UNITED STATES PATENT AND TRADEMARK OFFICE

APPLICATION NO.	FILING DATE	FIRST NAMED INVENTOR	ATTORNEY DOCKET NO.	CONFIRMATION NO.
09/954,806	09/18/2001	Hiroyuki Akashi	09792909-5185	8207

Office Action Summary

7. Claims 1-7 are rejected under 35 U.S.C. 102(b) as anticipated by or, in the alternative, under 35 U.S.C. 103(a) as obvious over the EP 997960 reference.

Figure 4 shows the thickness of a positive electrode active material layer wherein P represents the electrode layer (section 0119).

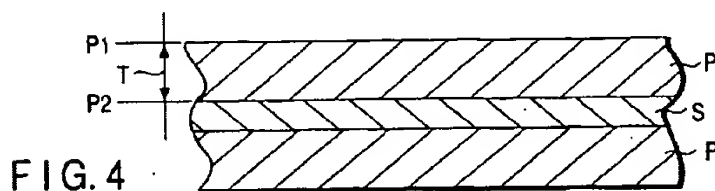
It is also disclosed that the positive electrode has a structure in which an electrode layer containing an active material is carried by one or both surfaces of the collector (section 0018). It is also disclosed that the negative electrode has a structure in which an electrode layer containing an active material is carried by one or both surfaces of the collector (section 0026)

The EP'960 reference teaches that the thickness of the positive electrode layer should be 10-100 μm ; it follows that where positive electrode layers are formed on both surfaces of the collector, one positive electrode layer has a thickness of 10-100 μm , naturally, the total thickness of the two positive electrode layers formed on both surfaces of the collector is 20-200 μm . It is

also disclosed that **the upper limit in the thickness is preferably 85 μm .** (section 0119/ 0158).

Hence, the EP'960 reference anticipates the claimed thickness, at least, from 80 to 100 μm when one layer is formed, and at least, from 80 to 200 μm when two layers are formed thereon.
